Guelph/Eramosa Township Hydrogeology Agency Review Document Book

Hydrogeology Review Document Book Index

**Re: ZBA Hidden Quarry – Township of Guelph/Eramosa
James Dick Construction
File No.: 300032475.0000**

**Figure C1:
 Monitoring Locations**

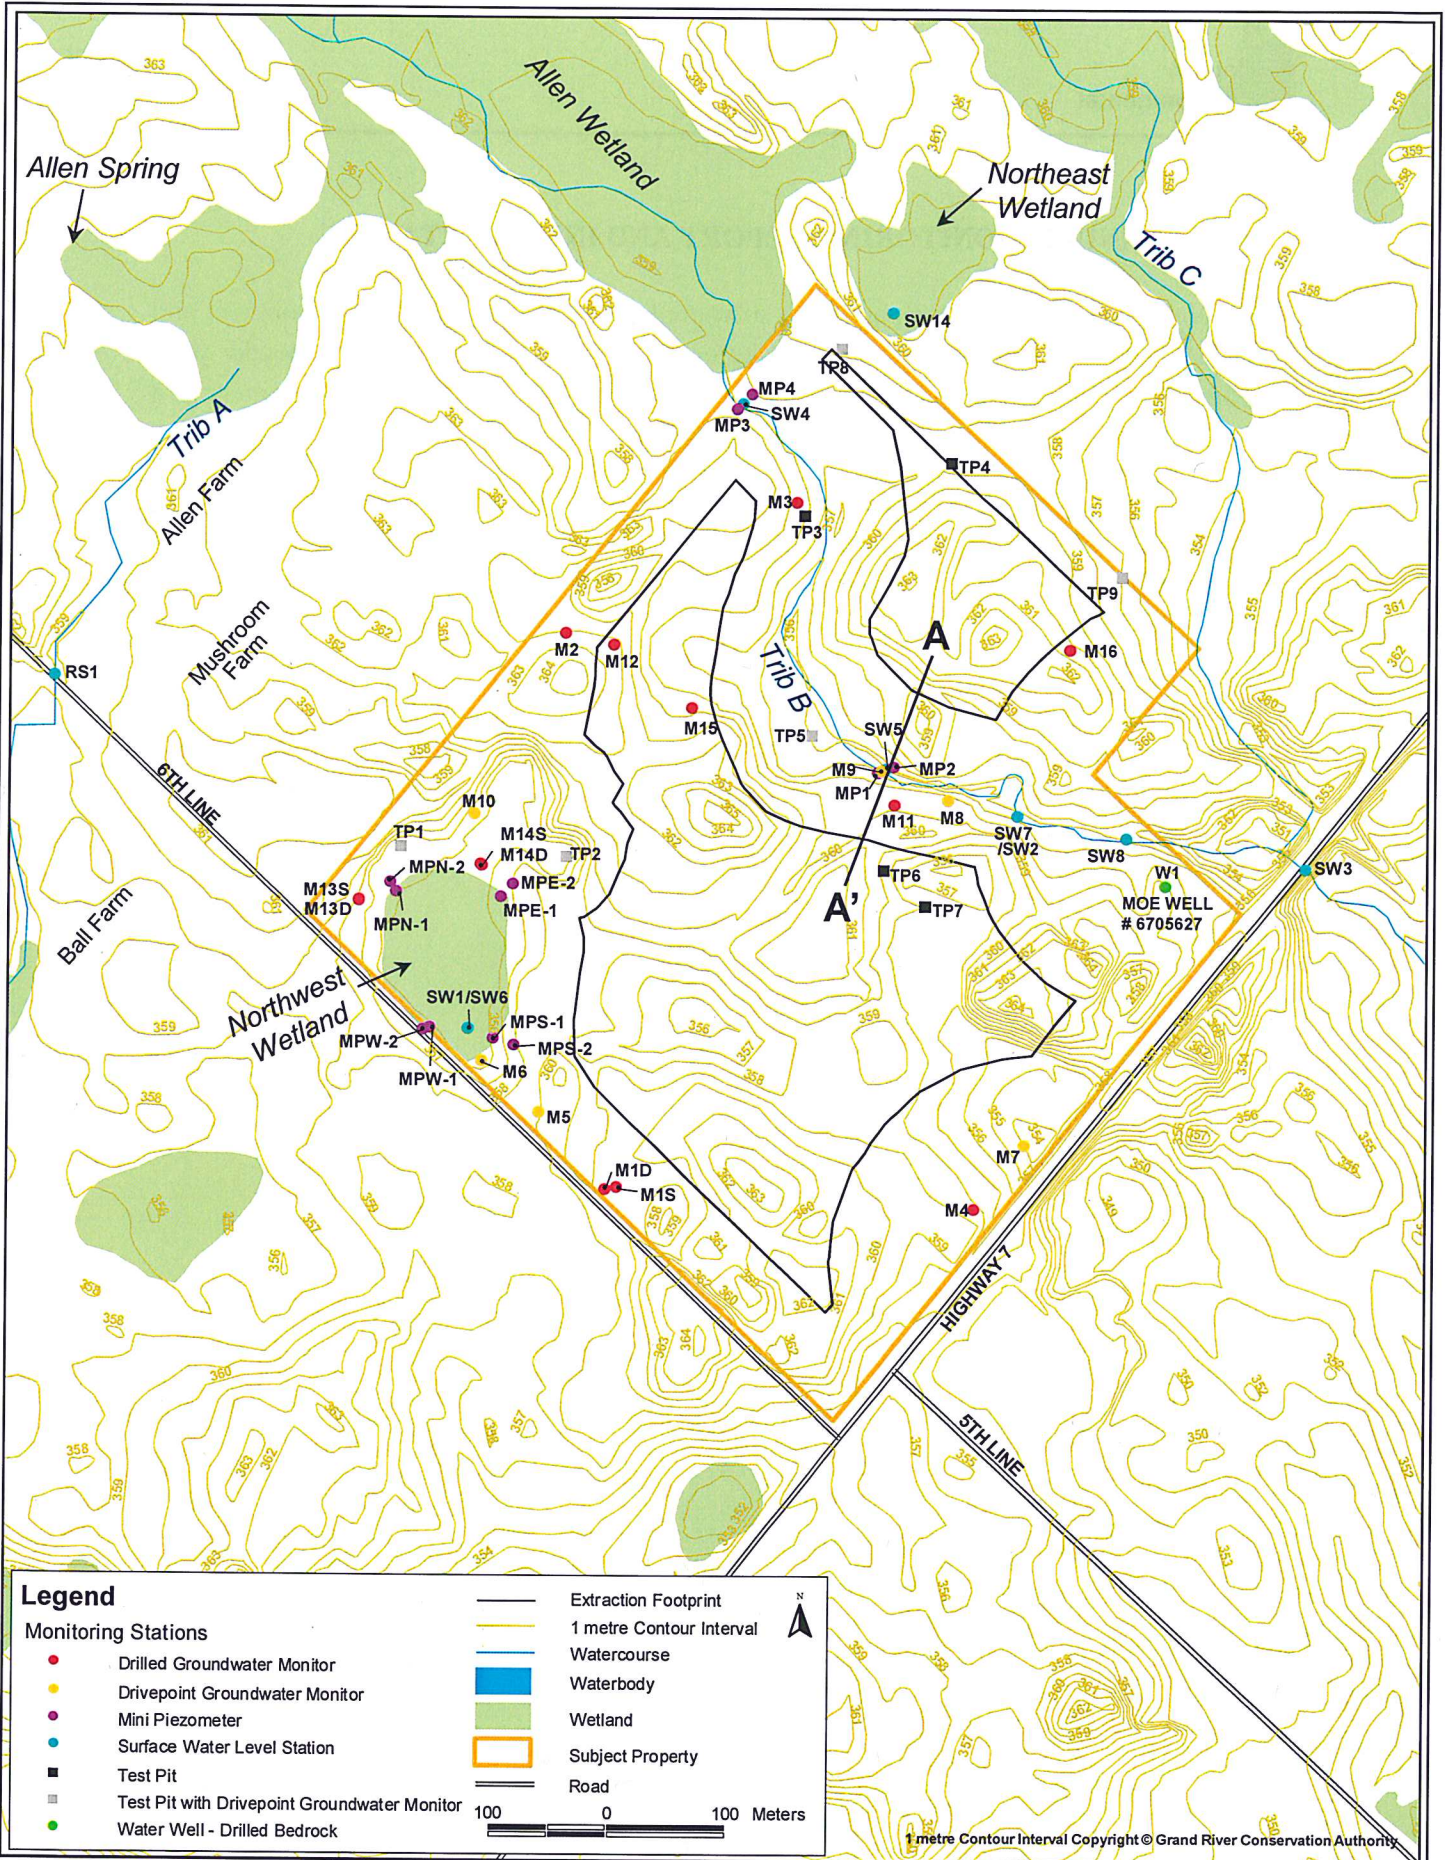
1. *Please provide Table C1 with updated monitoring to April 2014 in digital spreadsheet form. Also corresponding Fig C1 Hydrographs as available.*

13	Gary Hunter	20-May-14	Please provide Table C1 with updated monitoring to April 2014 in digital spreadsheet form. Also corresponding Fig C1 Hydrographs as available.	Tables submitted show data back to the 1990's. Data collection will occur according to the monitoring program and all data will be presented in the monitoring reports.	None
14	Gary Hunter	20-May-14	Does the Applicant have any information on the formational dip of the bedrock strata (top of Cabot Head) at the Hidden Quarry site?	The top of shale was encountered at an elevation of 308.52 m AMSL in M15 and 308.81 m AMSL in M2. The regional dip of the bedrock strata is estimated to be 0.2 to 0.3%, dipping towards the south west.	None
15	Gary Hunter	20-May-14	The Applicant has identified Goat Island Formation above 350 m asl in Borehole M15 at Hidden Quarry site. Is Goat Island present in other site boreholes where the bedrock surface is higher than about 350 m asl?	Bedrock was encountered at higher elevations in M2, M12 and TP9. It is possible that the Goat Island formation is present at those locations.	None
